## SERVICE INFORMATION NO. SI 42-205

Technify Motors Service Bulletin TMG 125-1020 P1  
ATA-Code: 72-00

**Service Bulletin No. / Date:** SB TMG 125-1020 P1, Initial Issue / January 27, 2016

**Subject:** Gearbox Oil Leak Inspection

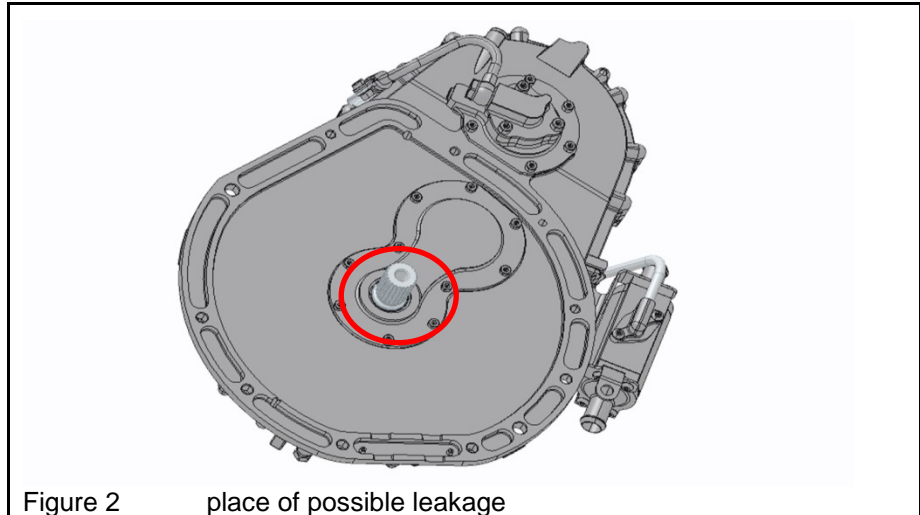
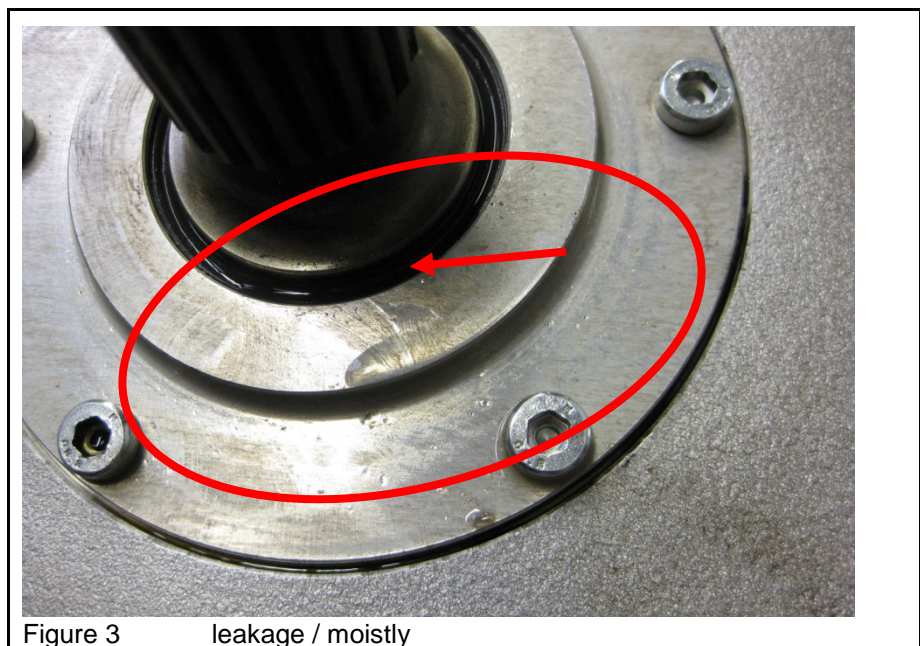
**Reason:** Radial shaft sealing ring may not seal properly due to an improper lapped gearbox drive shaft. This can lead to an oil leak and a slipping clutch and finally to a loss of power.

- Remove the gearbox and replace the clutch by dual mass flywheel in accordance with RM-02-02, Chapter 72-10.18, Issue 3, Revision - or later approved revisions.
- Inspect the gearbox, check the rear radial shaft sealing ring on the gear shaft for oil leakage and moisture, see Figure 2 and Figure 3.

- If there is a leakage or moisture, see Figure 3, replace the gearbox.
